**SUBJECT:** Sixth Five-Year Remedy Review Report for Savannah River Site Operable Units with Operating Equipment (U) Aiken, South Carolina (SRNS-RP-2022-00468, Revision 1, June 2023) (Redline Pages), Sixth Five-Year Remedy Review Report for SRS Operable Units with Operating Equipment Fact Sheet (SRNS-RP-2022-00488, June 2023) (Redline), and Savannah River Site's Responses to the Regulatory Comments on the Revision 0 Document, SEMS Number: 00

**SRS Responses to U.S. Environmental Protection Agency Comments on the  
Sixth Five-Year Remedy Review Report for Savannah River Site Operable Units with  
Operating Equipment (U), SRNS-RP-2022-00468, Revision 0, December 2022**

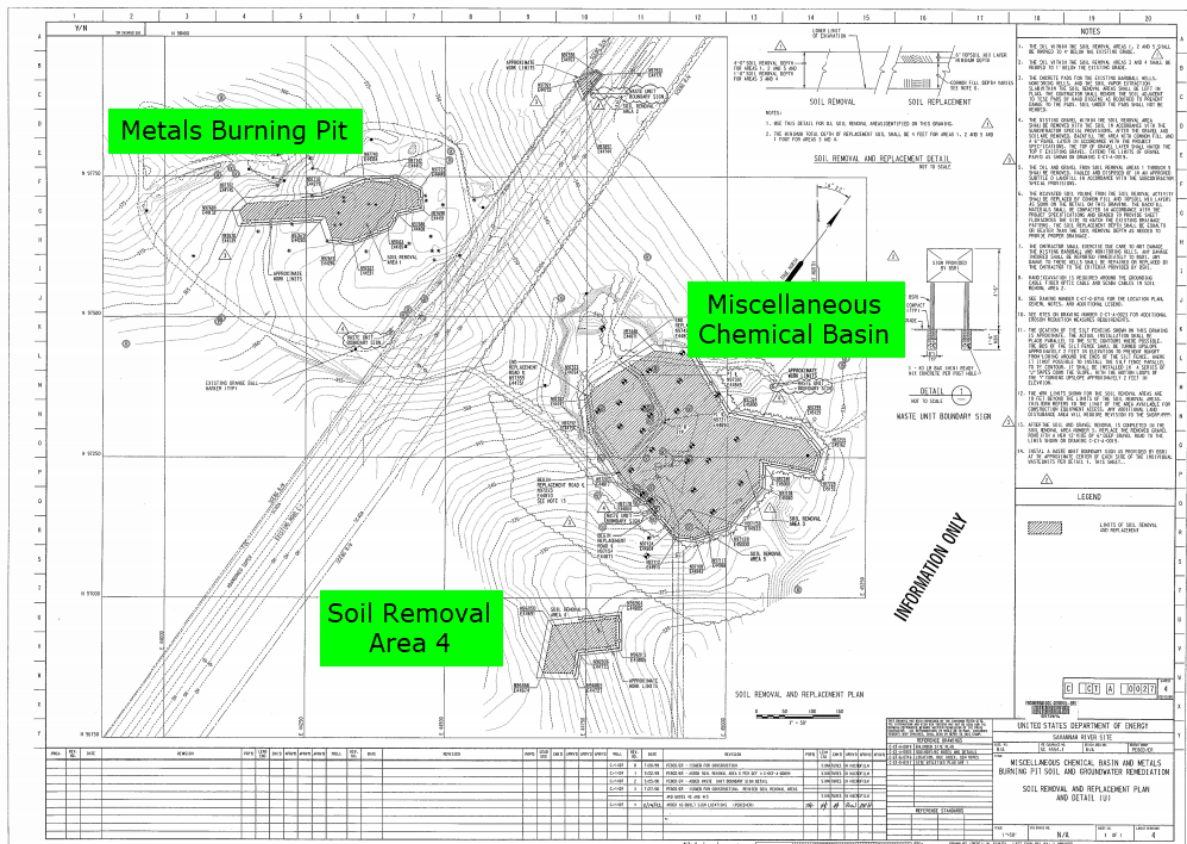
- 5. Appendix C, Section VI, Five-Year Review Process, Summary of Inspections and Interviews, Page C-15 of C-58:** The text states, “Since the MBP [Metals Burning Pit (731-5A)] and SRA 4 subunits are outside of the established LUC boundary and no further problems warranting action exist in the MBP surface soil subunit and SRA 4 (WSRC 2008), inspections were discontinued in 2022;” however, the location of soil removal area (SRA) 4 is not provided (e.g., on Figure C-3, ABRP/MCB/MBP OU Subunits Layout). In addition, Section IV (Remedial Actions) identifies the remedy for MBP Surface and Subsurface Soil as excavation and LUCs, so it is unclear why it is noted that this area falls outside the LUCs boundary. *Please revise the FYR Report to clarify the remedy for MBP, including if LUCs are necessary at this area. Please also provide the location of SRA 4.*

**Per the Land Use Control Implementation Plan for the A-Area Burning/Rubble Pits (731-A, -1A) and Rubble Pit (731-2A) and the Miscellaneous Chemical Basin/Metals Burning Pit (731-4A and -5A) Operable Unit, the final selected remedy for MBP surface soils was excavation of contaminated soils. Confirmatory sampling was performed to verify that remedial goals were met. The excavation was backfilled with clean soil. No further problems warranting action exist at the MBP subunit, therefore LUCs are not required.**

**In a similar fashion, Soil Removal Area (SRA) -4 was also being inspected when there was no requirement to do so. Per the *Interim Post-Construction Report (IPCR) for the Miscellaneous Chemical Basin/Metals Burning Pit (731-4A/5A) Operable Unit (U)* (WSRC-**

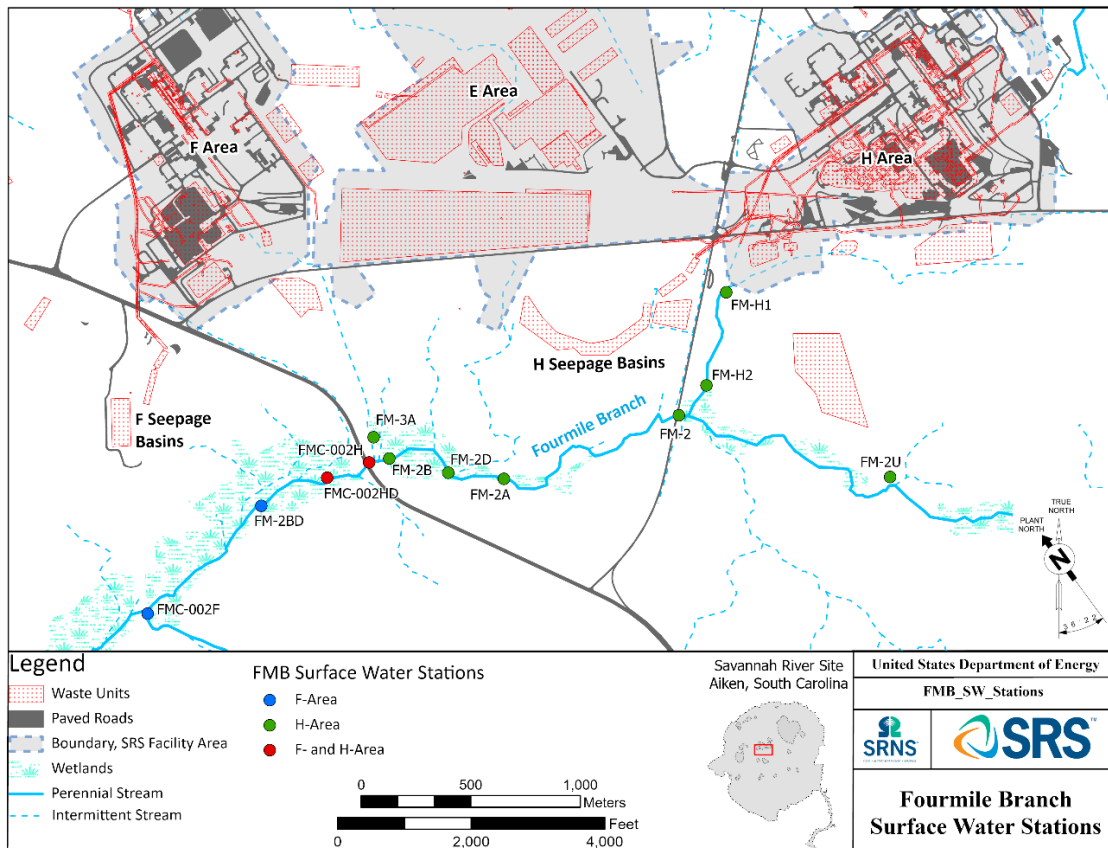
impacts to Fourmile Branch in each appendix do not correlate to the surface water stations at the sites, and it is unclear why site-specific surface water data were not reviewed. In Appendix H, the surface water data are provided for four stations (i.e., FMC002H, FMC002HD, FM2BD, and FMC002F) but these stations do not appear to be shown on Figure H-2 (F-Area Groundwater OU Treatment Systems Locations; note that the low resolution of Figure H-2 makes it difficult to determine the sample identifications). In Appendix I, data from ten surface water locations are discussed, but Figure I-3 (Treatment Systems for the H-Area Groundwater OU) identifies five different surface water stations. *Please revise Appendix H and Appendix I to show the locations of the surface water stations used for the data review, and to include site-specific surface water data if available.*

**The site-specific surface water data was reviewed for both F-and H-Area Groundwater OUs. The following figure showing the location of the surface water stations for both areas will be added to both appendices. The figure will be numbered and titled appropriately.**

**Figure F-10. CBRP Plume Cross Section, Fourth Quarter 2000**

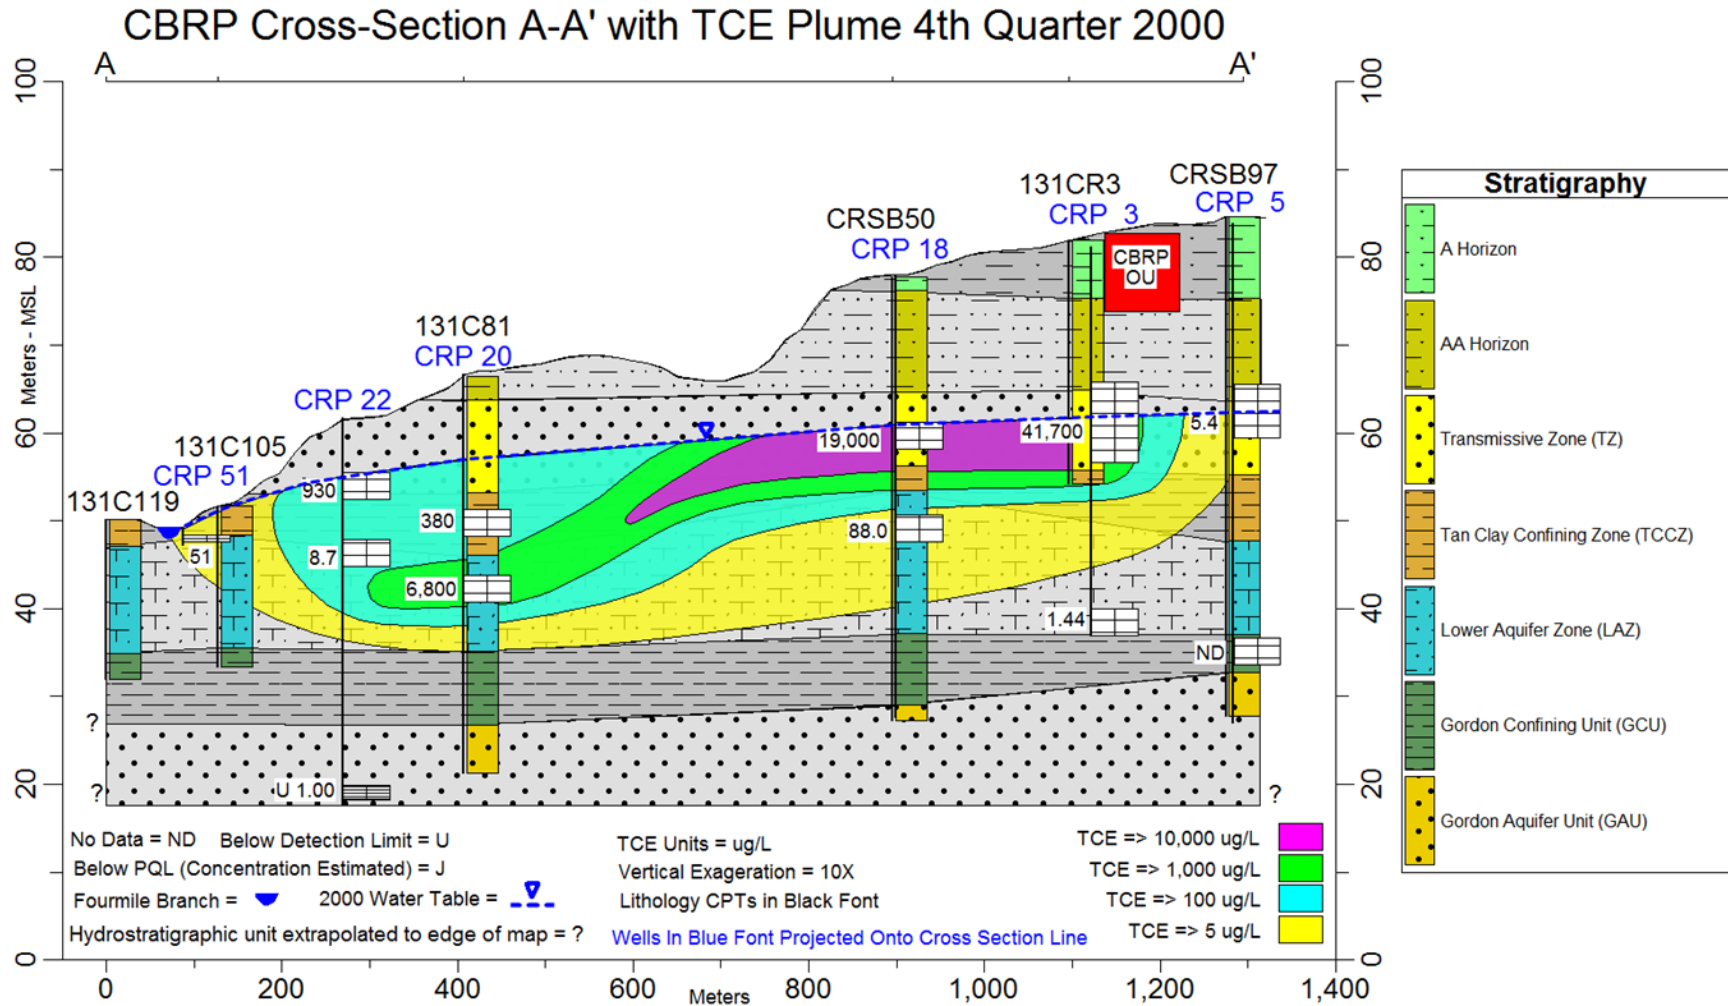
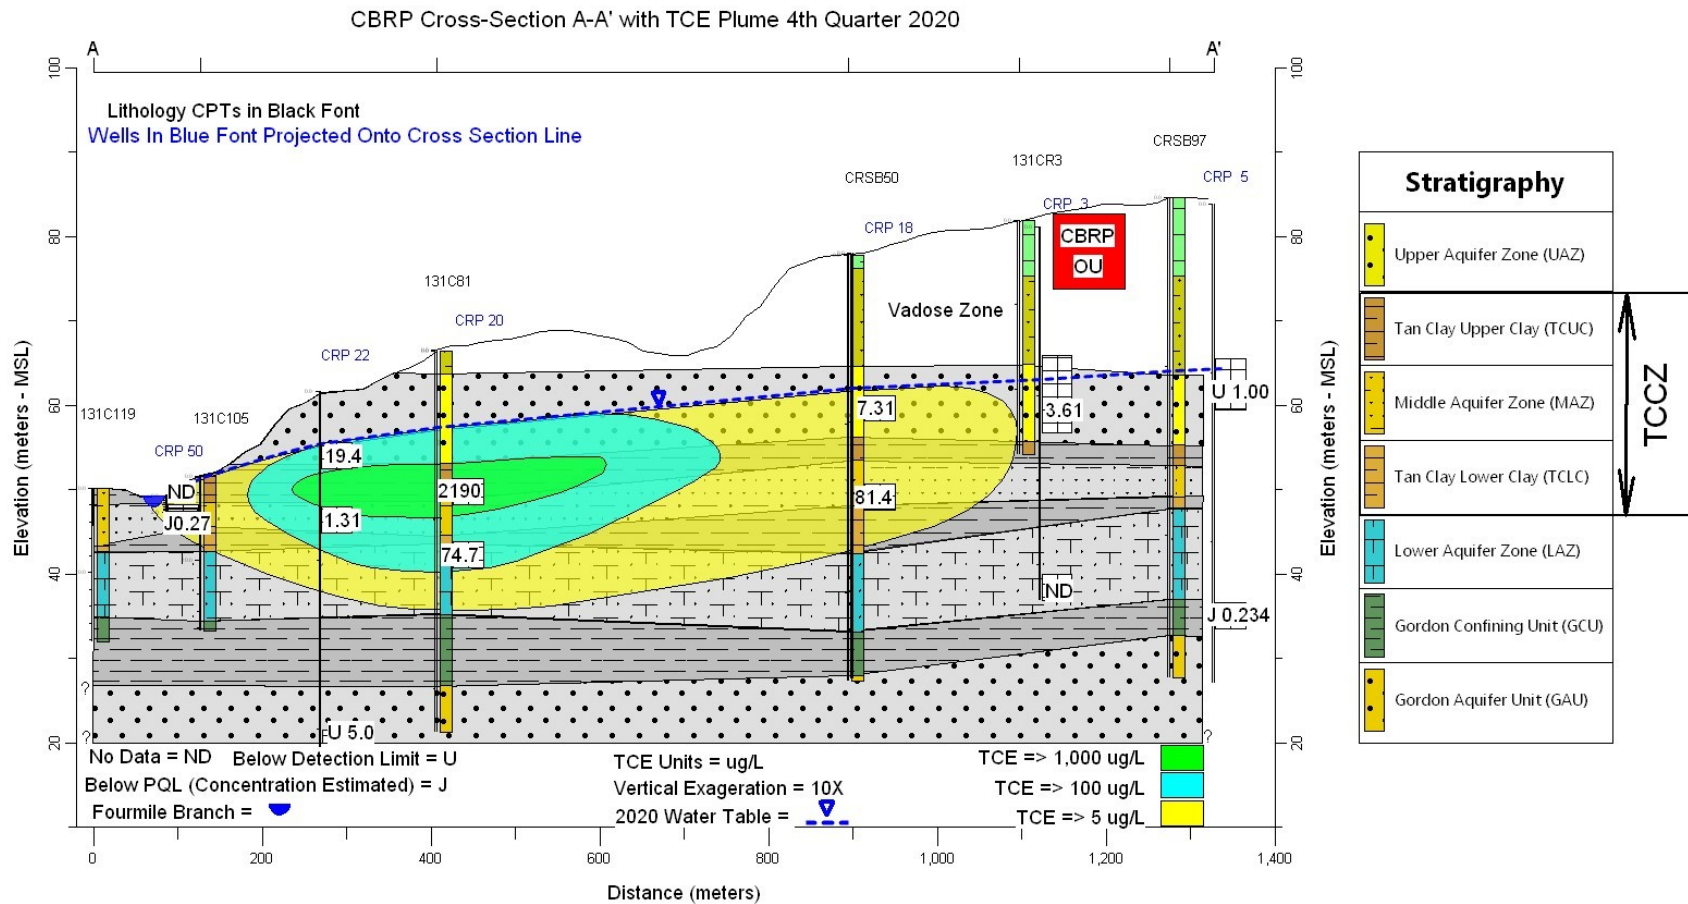
- b. The recent groundwater and surface water sampling data and a figure showing the current groundwater plume configuration are not provided for the C-Area Burning/Rubble Pit (131-C) and Old Burning/Rubble Pit (No Building Number [NBN]) (CBRP) OU (Appendix F). Therefore, it is unclear how the groundwater remedy is progressing towards cleanup and if monitored natural attenuation (MNA) is successfully reducing constituent of concern (COC) concentrations. For example, the text states that concentrations are decreasing across most of the plume (i.e., except wells CRW 10C and CRW010CU) but trend graphs are not provided. It is also unclear if the plume is migrating. In addition, since data for the natural attenuation parameters are not discussed

**Figures F-10 and F-11 (attached to the comment responses) will be added to Appendix F. They depict the CBRP OU TCE plume in 2000 and 2020 and show the decrease in TCE groundwater concentrations over that time-period as the plume migrated from the CBRP OU Pit towards Fourmile Branch. The following sentence will be added to Data Review in Section VI:**

**“Figure F-10 and Figure F-11 demonstrate the decrease in TCE groundwater concentrations from 2000 to 2020 as the plume has migrated from the CBRP OU pit towards Fourmile Branch. The figures show that the TCE source to groundwater from the CBRP OU pit has been cut off.”**

**Figure 1. Maximum TCE concentrations for C-Area (1985- 2016)**

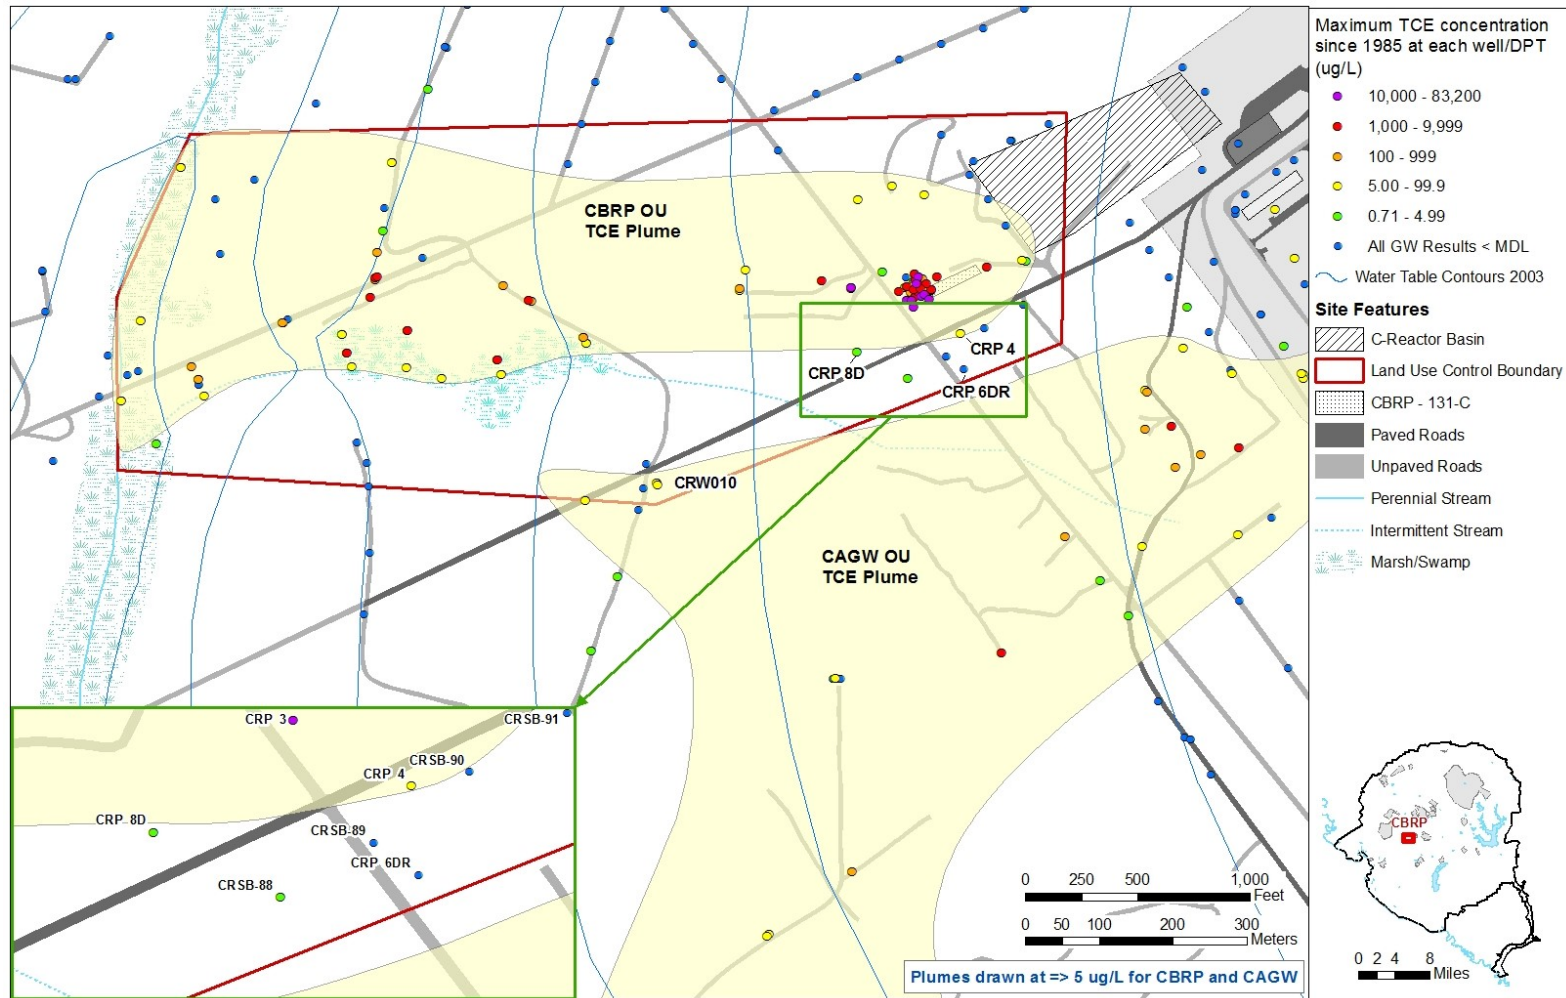
The text states, “The MNA wells and surface water sampling show decreasing contaminants over time except for two wells (CRW 10C and CRW010CU), and CRW010CU displays concentrations exceeding the TCE trigger level;” however, the trends at these two wells are not discussed (i.e., if TCE shows steady or increasing concentrations). Further, since TCE concentrations exceed the trigger level at well CRW010CU, it is unclear if any actions are necessary to ensure protectiveness. *Please revise Section VI to discuss the trends in concentrations at CRW 10C and CRW010CU, including if any actions are necessary at these wells to ensure the groundwater plume at this location meets RAOs.*

Figure 1 shows the 2003 water table contours. The water table contours indicate that groundwater at the CRW 10 cluster originates from the reactor area, rather than from the CBRP area. The CBRP OU groundwater modeling particle tracks also indicate the predominant flow path from the CBRP OU is towards Fourmile Branch (Figure 2). Monitoring well CRP 8D is located between the CBRP OU and CRW 010CU. The maximum TCE concentration at CRP 8D was only 1.24 µg/L, in 2003, which suggests that it is very unlikely that a flow path exists connecting CRW010CU with a source at the CBRP OU.

Figure H-3. Time trends of Iodine-129 concentrations at wells FSB 146D, FSB 143D and FSB 130D.

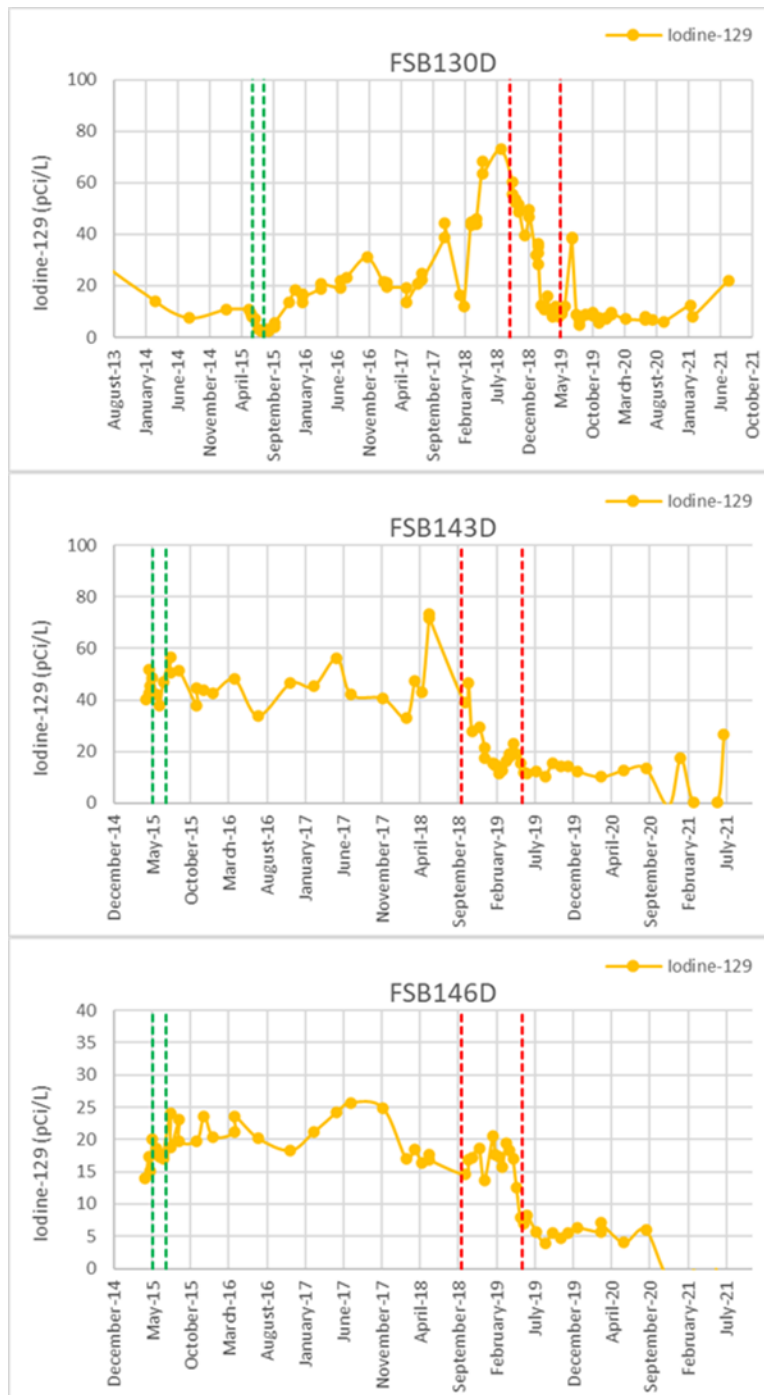
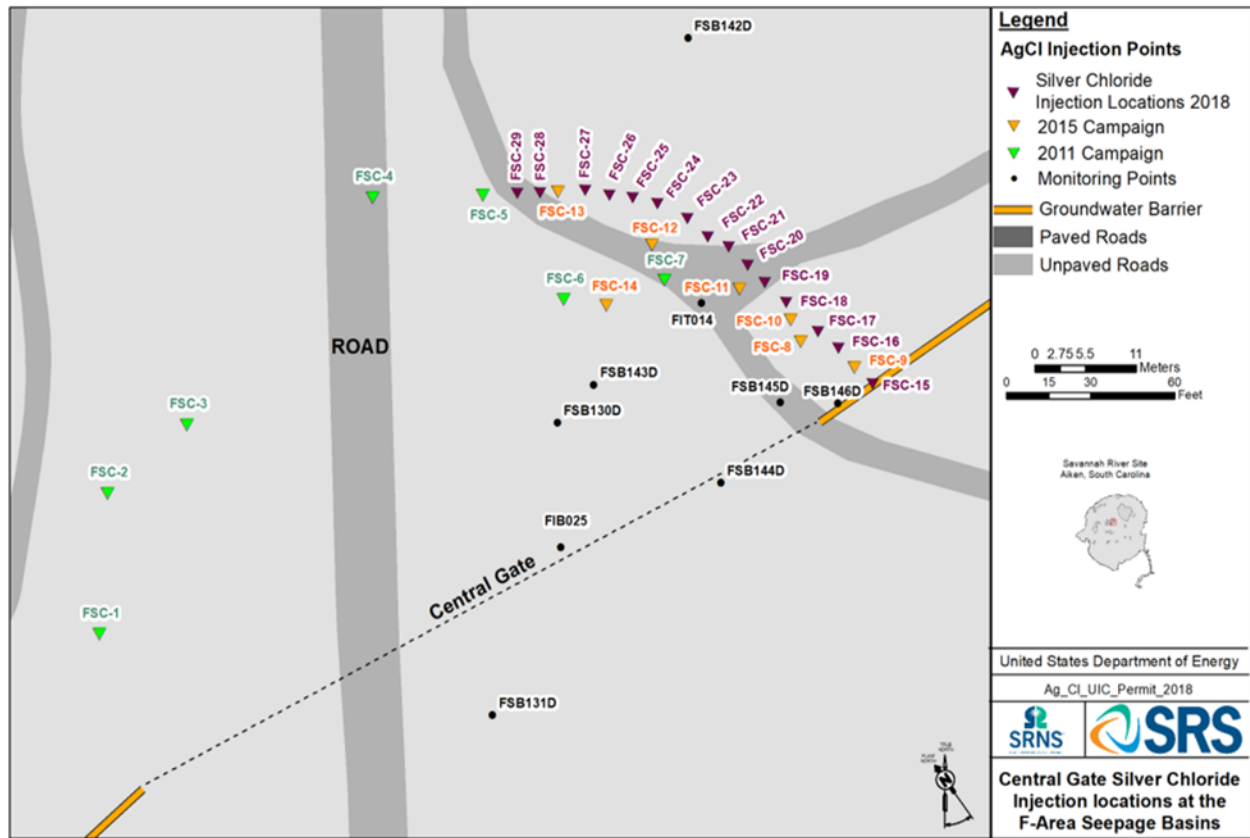
- f. The iodine data for the most recent injection of silver chloride at the central gate of F-Area (Appendix H) should be provided to support the statement that the injections were demonstrated to be effective at sequestering iodine-129 in situ. This includes data for monitoring points closest to the injection that show the greatest reduction in concentration and includes wells further away that show less of an impact.

**“...sequestering iodine-129 in situ. Variations in the degree of reduction have been observed during each deployment. Monitoring data at several well locations have shown that the 2018 silver chloride injection campaign was effective in reducing iodine-129 concentrations. In one of the wells (FSB 146D) close to the injection points, a reduction of approximately 58 – 75 percent in iodine-129 concentration occurred after the injection period and has persisted for over two years (Figure H-3). Wells FSB 143D and FSB 130D also saw attenuation of iodine-129 after the injection period with reductions in iodine concentration between 63 – 69 percent and 58 – 69 percent, respectively (Figure H-3). Monitoring points closest to the injection show the greatest reduction in concentration and wells further away show less of an impact (Figure H-4). SRS is continuing to evaluate the effectiveness of the permeable in situ treatment zone and continues to evaluate the need for additional silver chloride injection(s) in the future.”**

**Figures H-3 and H-4 are included with these comment responses. Additionally, this information is available in the annual RCRA Corrective Action Report.**
